Fast-Track project name: Downtown Carpark Site Development

Fast-Track application number: FTAA-2512-1158
BUN60460864, LUC60460865, DIS60460866 and WAT60460867

2.0 Technical Specialist Memo – Pedestrian Wind Effects

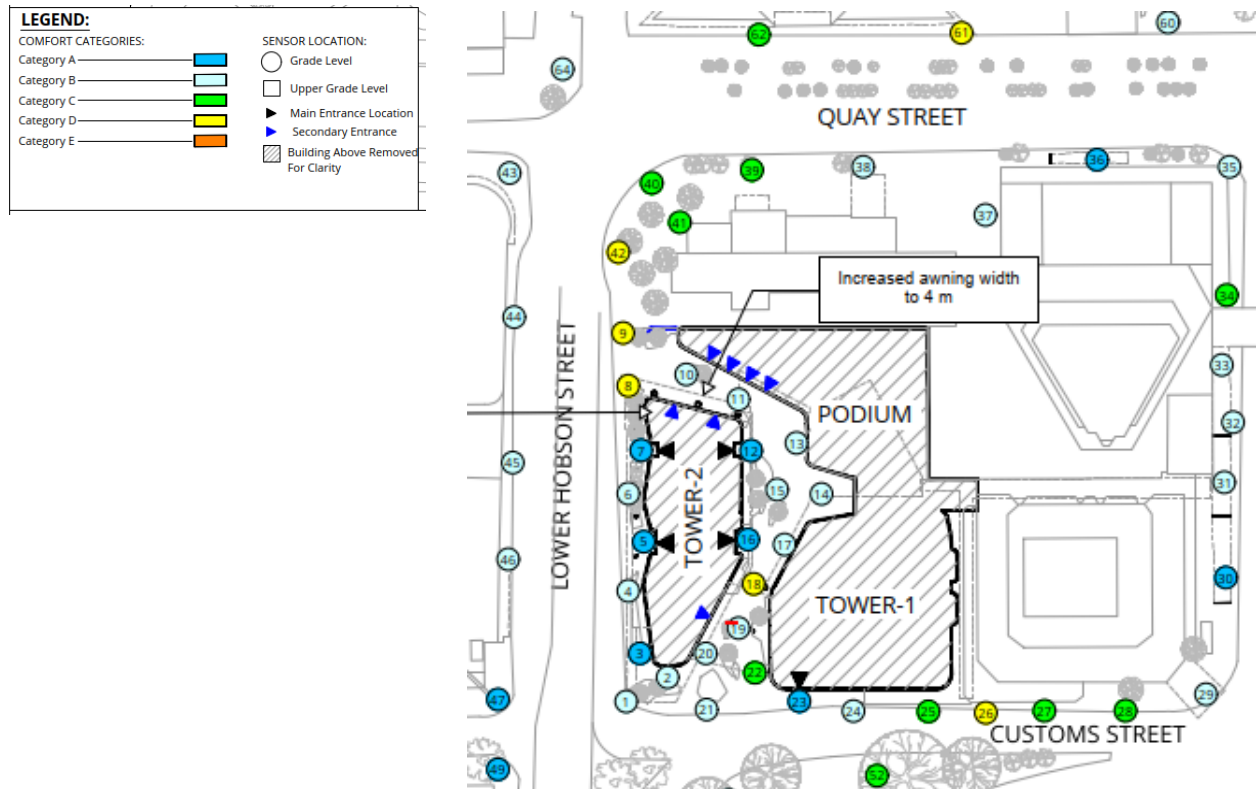
- 6.9. The Holmes/RWDI wind report describes testing of a range of building configurations with different suites of mitigation measures and model changes. These configurations consist primarily of the inclusion of existing and additional trees and vegetation, an extension of the free roof between the podium elements, a canopy along part of Lower Hobson Street, and various short porous or solid 2.5m high vertical screens. The image below, which is taken from the Holmes/RWDI wind report, shows the elements included in the final/proposed configuration.

6.10. The image below, also from the Holmes/RWDI report, shows the AUP wind categories for the proposed development with the above combination of existing vegetation and mitigation measures included.

6.11. The image in 6.10, together with the wind speed data provided in the Holmes/RWDI report, show that there are five locations outside the site (locations 8, 9, 26, 42 and 61), and one within the site (location 18), where Category D conditions are reported, and where under the AUP wind rules Category C conditions or better are anticipated according to the expected use. At location 9 the maximum gust speed of 26m/s also marginally exceeds the 25m/s AUP Safety Criteria.
